ALERT SERVICE BULLETIN

NO. 407-09-86

MODEL AFFECTED: 407

SUBJECT: VERTICAL FIN ASSEMBLY 206-020-113-233,
INSPECTION OF

Figure 1 (sheet 1 of 2) – Vertical fin assembly, inspection and repair of

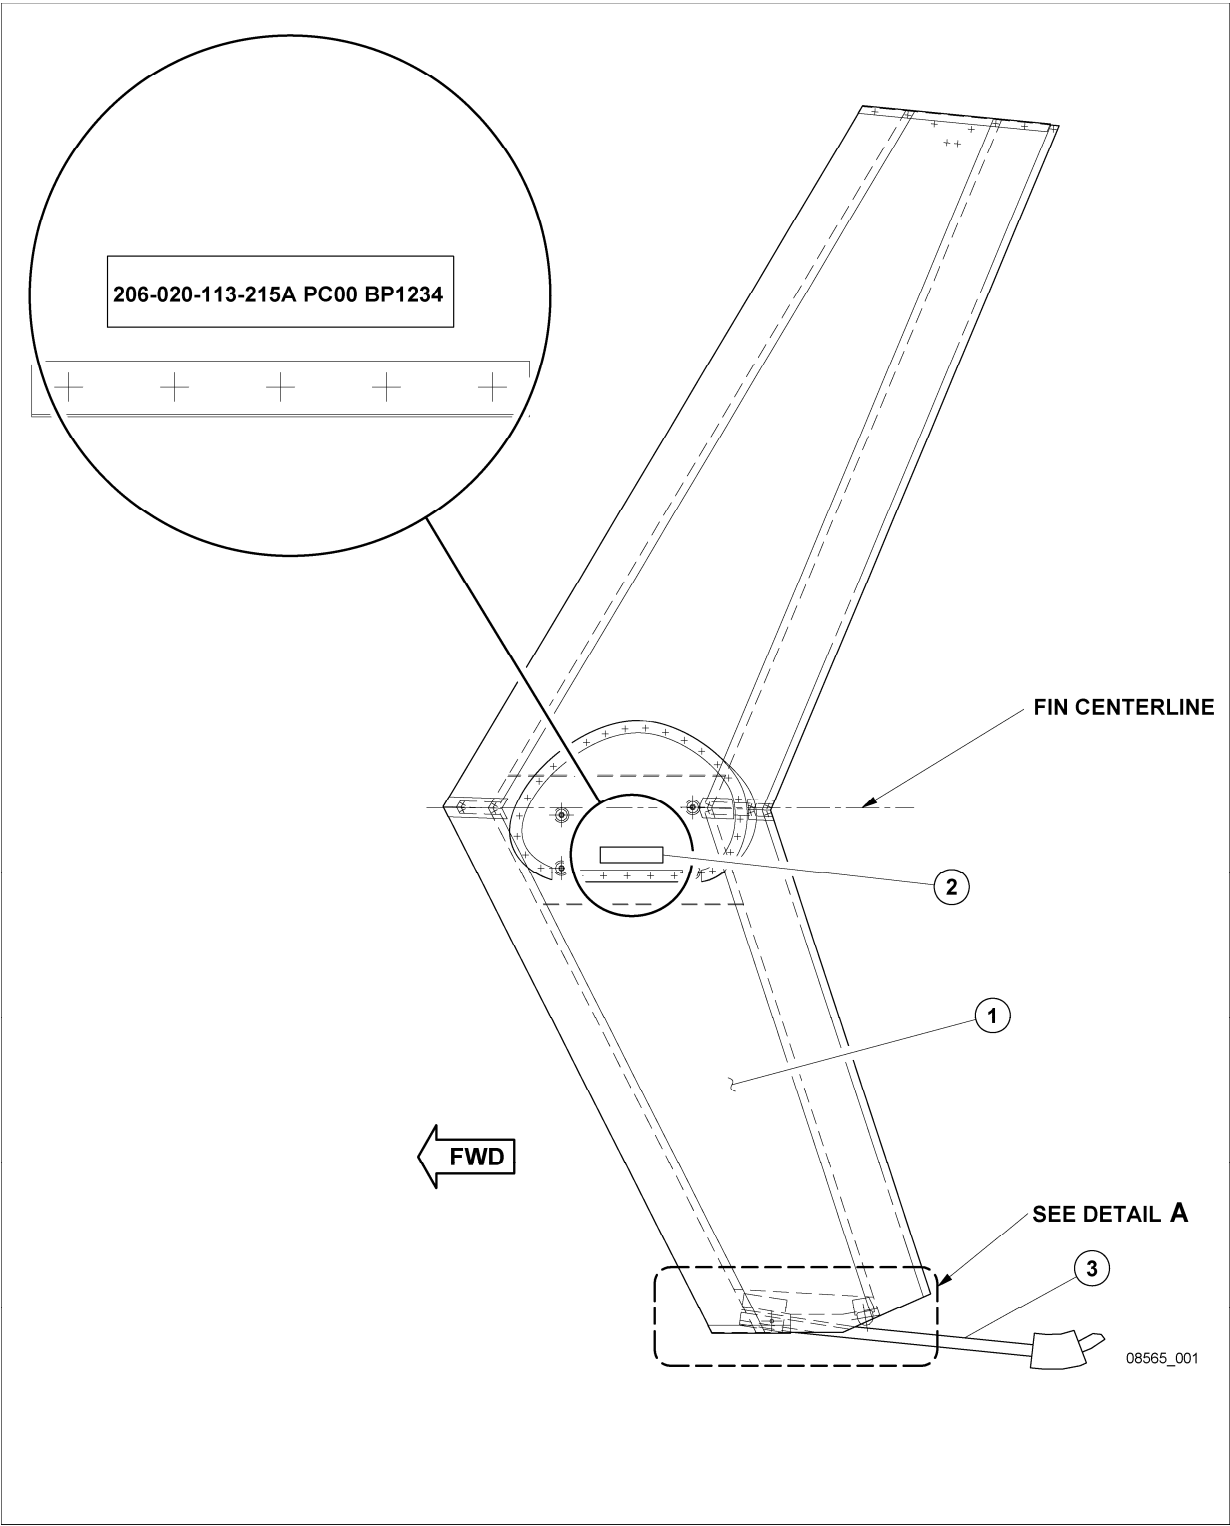
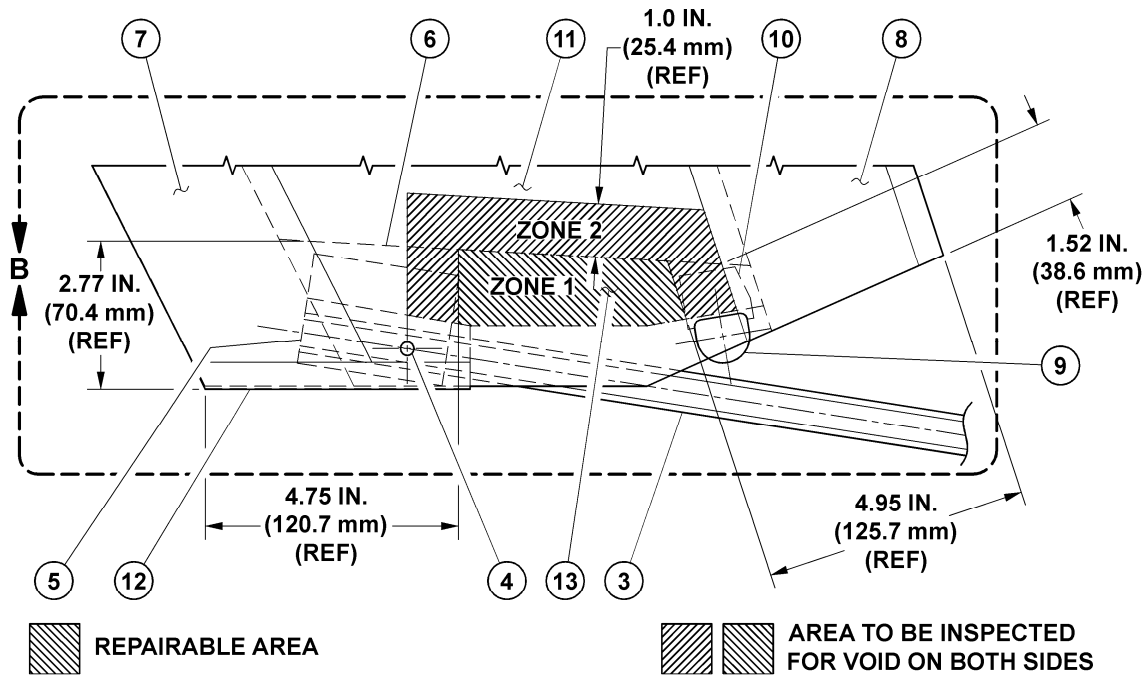
3. Refer to Figure 1. Determine if you have an affected vertical fin assembly (1) using the serial number of the core 206-020-113-215A as listed in Table 1. An identification tag (2) showing the P/N 206-020-113-215A followed by its serial number is bonded on the fin assy as shown in the Figure 1.
4. If the serial number of the core is not listed in Table 1, reinstall the tail rotor gearbox fairing in accordance with BHT-407-MM and make an entry to indicate that this bulletin has been accomplished.
5. If you have an affected vertical fin assembly, accomplish Part II of this bulletin.

1. Refer to figure 1, detail A. Using the tap test method, inspect Zone 1 and Zone 2 on each side of the vertical fin assembly skin (11) in the lower area shown on the Figure 1 for voids between core (13) and inner doubler (6).
2. Record size and total area of the void, if any.
3. Verify the limit of void for each Zone. Limits are as follows for Zone 1 and Zone 2.
 - a. Zone 1 and Zone 2: If no void is found or if any single void does not exceed 0.25 square inch and the total voided area is less than 10% of the affected area, vertical fin assembly is serviceable and does not require repair or replacement. Accomplish Part IV of this bulletin.

- b. Zone 1: If any single void exceeds 0.25 square inch or if the total voided area exceeds 10% of the affected area. Accomplish Part III of this bulletin.
 - c. Zone 2: If any single void exceeds 0.25 square inch or if the total voided area exceeds 10% of the affected area. The vertical fin is not repairable and must be removed from service immediately. Order a new replacement fin and reinstall in accordance with the appropriate Maintenance Manual. Make an entry to indicate that this bulletin has been accomplished.
4. Notify your local CSR and Product Support Engineering that non-repairable vertical fin assembly has been removed from service and destroyed.

Figure 1 (sheet 2 of 2) – Vertical fin assembly, inspection and repair of

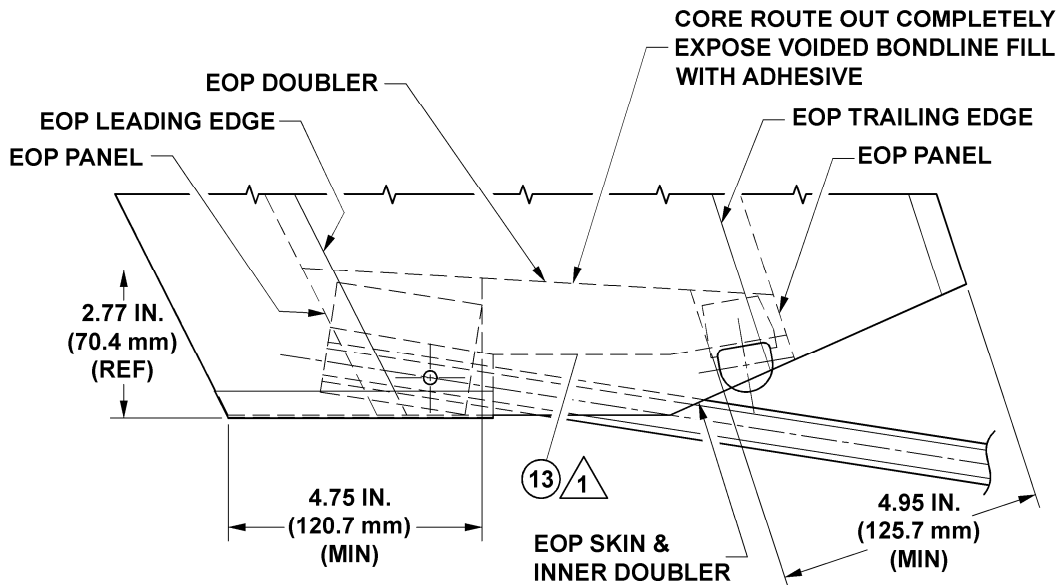
1. Refer to BHT-407-MM. Remove tail skid assembly (3) from the vertical fin (1). Keep for reinstallation.
2. Remove the vertical fin assembly (1) from the helicopter, if installed.
3. Position vertical fin assembly (1) on a padded working table.
4. Refer to Figure 1, detail B. Remove layer of sealant covering the lower portion of the core (13).

5. Remove and route the entire honeycomb core (13) as shown in detail B with care. Exceeding the maximum area that is permitted will cause the vertical fin to be replaced.
6. Inspect the exposed area of core inside the vertical fin (1), and inner doublers (6) for corrosion, contamination, or any other damage. If such damage exists, contact Product Support Engineering for further assistance.

8. Clean surface of the inner doublers (6) with Acetone C-316 or equivalent.
9. Position and secure the vertical fin assembly (1) upside down.
10. Fill exposed area with adhesive C-317 and allow curing at room temperature for 24 hours.
11. Inspect the repair areas for voids and unbonded areas using the tap test method. Voids shall not exceed 10% of the total area that has been repaired . No one single void shall exceed 0.25 square inch. Repeat step 5 thru 10 if any voids are exceeding these limits.
12. Seal lower edge of the vertical fin with sealant C-392 and allow to dry.
13. Refinish vertical fin assembly as required.
14. Refer to BHT-407-MM. Reinstall vertical fin assy (1) on helicopter.
15. Reinstall the tail skid assy (3).
16. Accomplish Part IV of this bulletin.

1 Cover entire edge of exposed core with sealant MIL-PRF-81733.
